purpose of issue
CONSTRUCTION

project
BICESTER ECO TOWN EXEMPLAR SITE

drawing
ENERGY CENTRE Roof Plan

drawing no AA2699C/4.1/352	rev E
drawn DGH	checked MDB
scale @ A1 1:50	date Jan 2013

Roof Plan

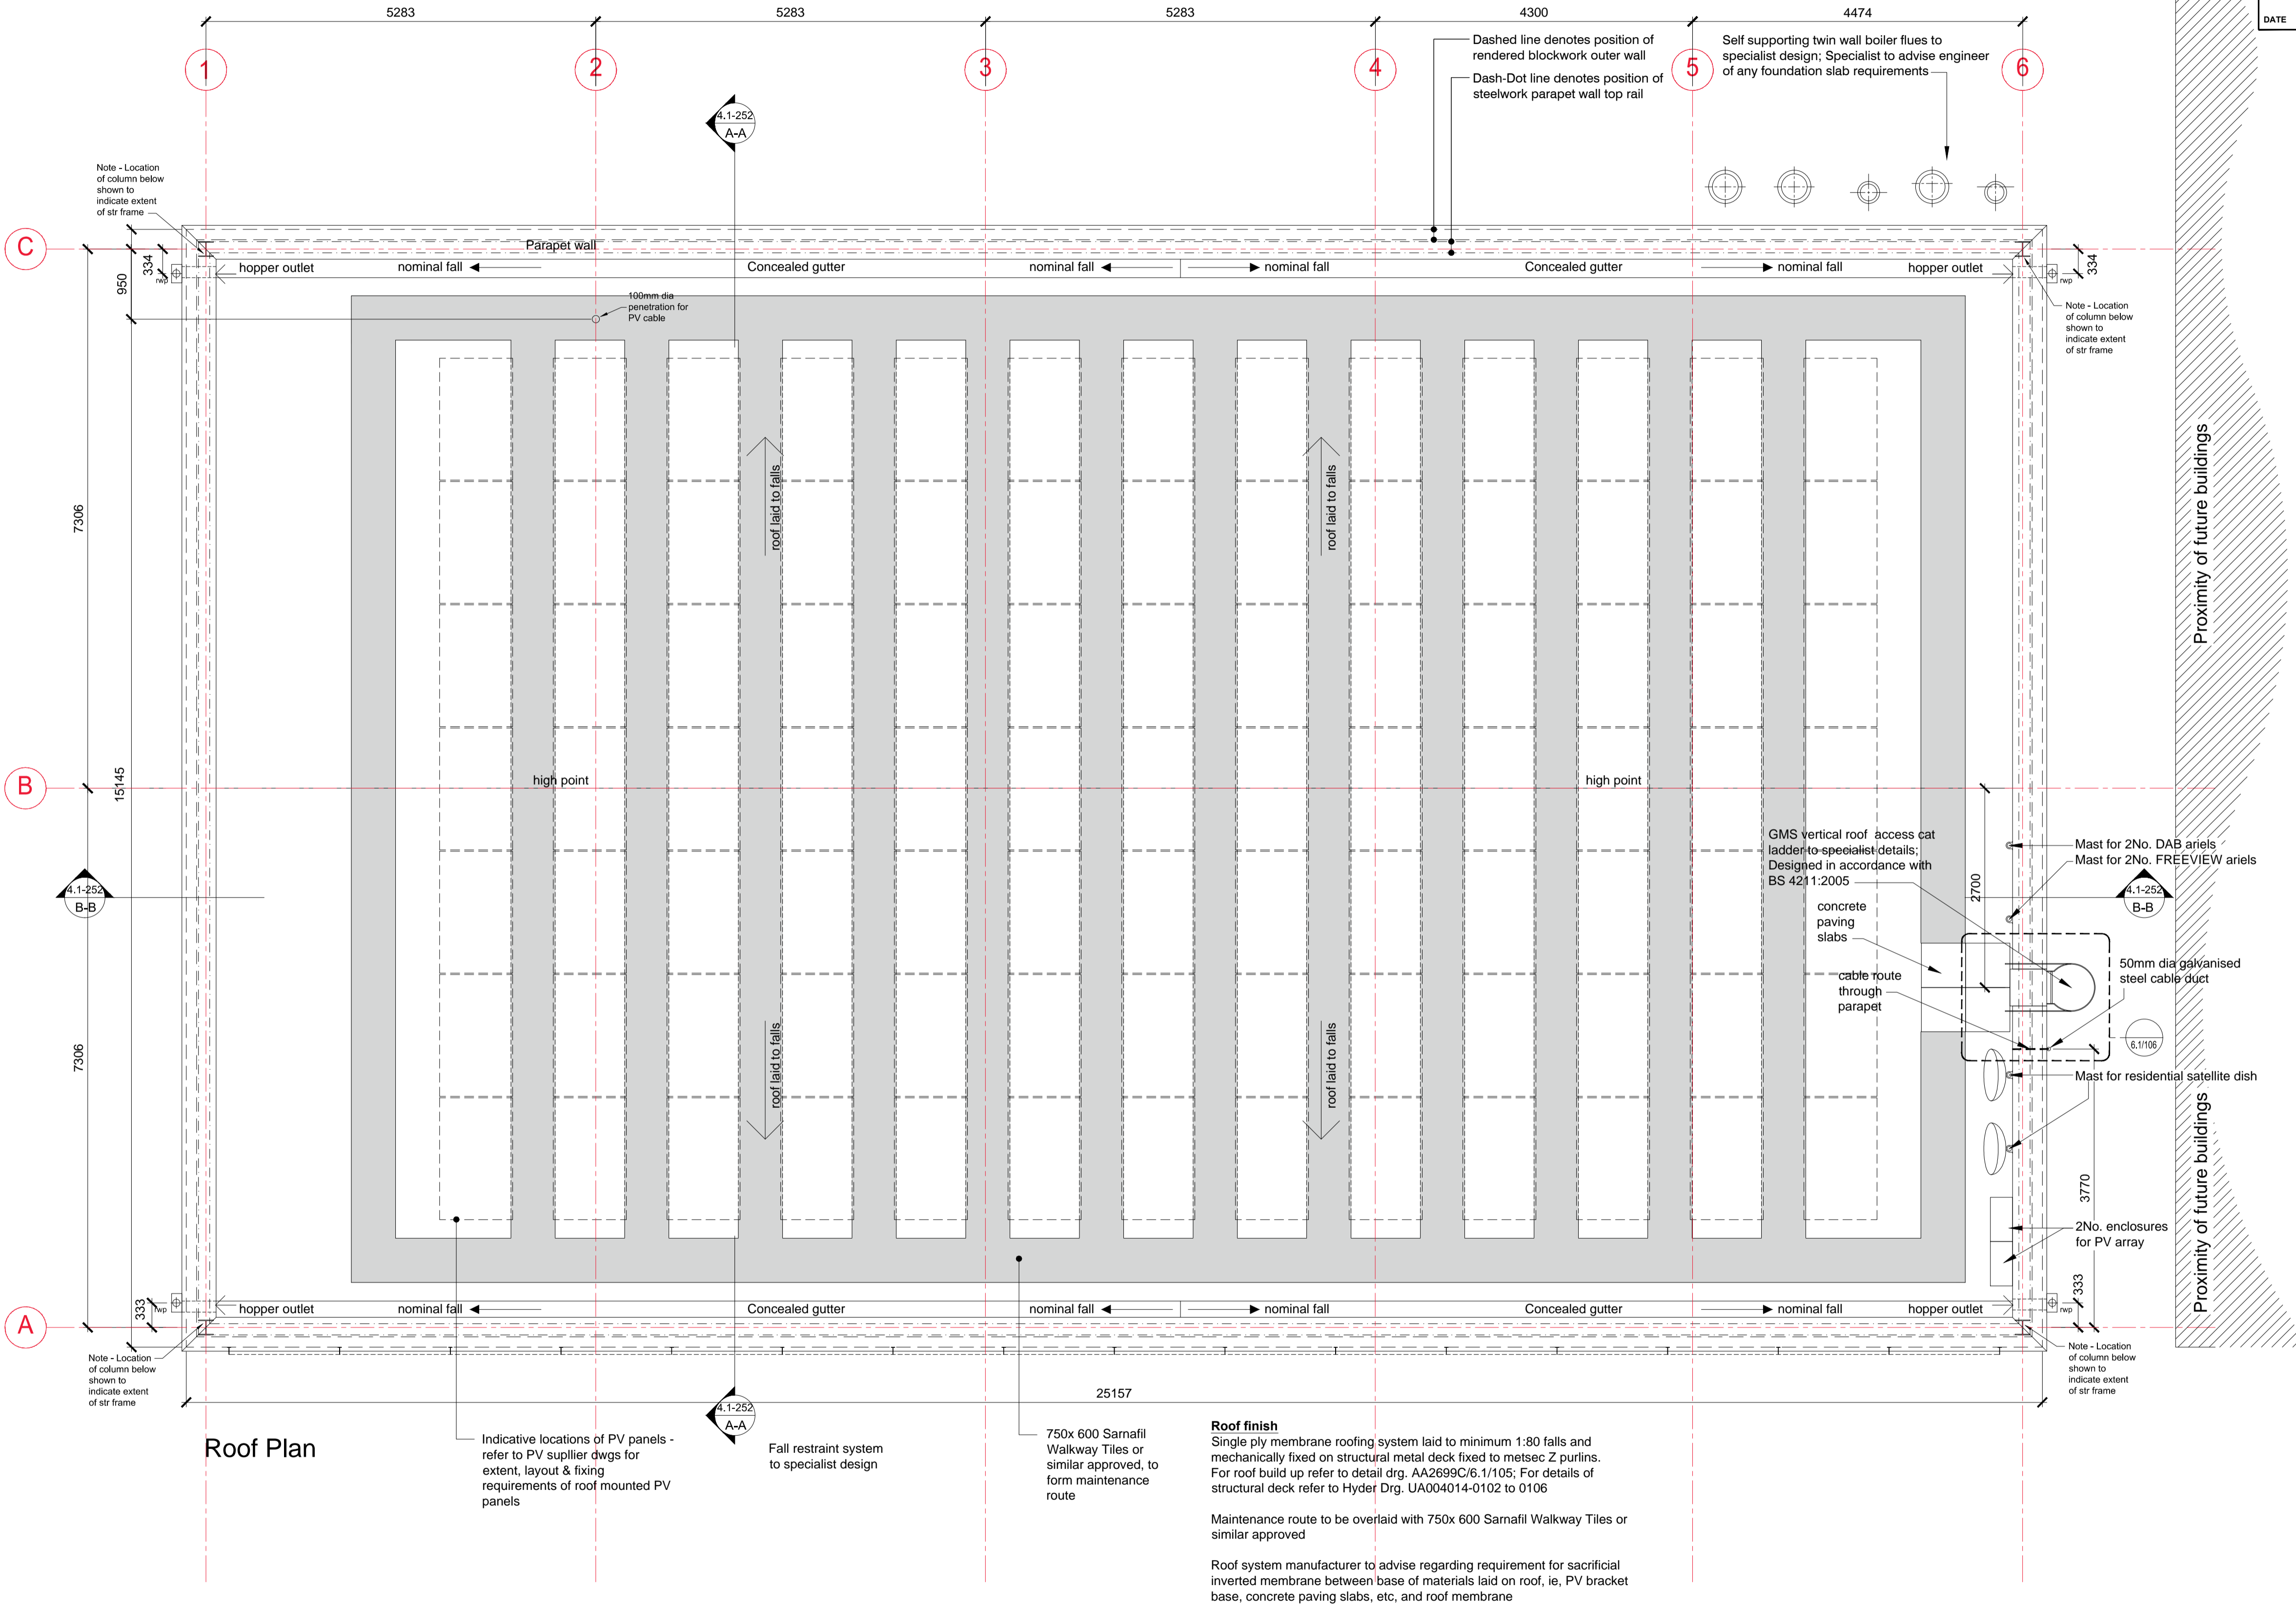
date	rev	revision/author/checker
07-05-2015	E	Amended to WDH comments. Notes amended, sacrificial path added; IM/C/L
28-04-2015	D	Amended to WDH comments. PV layout updated in line with specialist drawing. Roof penetration added as clouded. Issued for Construction; IM/C/L
01-08-2014	C	Drawing updated in line with current engineer's information; JWW/MH
19-02-2013	B	Additional information added - I/LA
12-02-2013	A	First Issue DGH
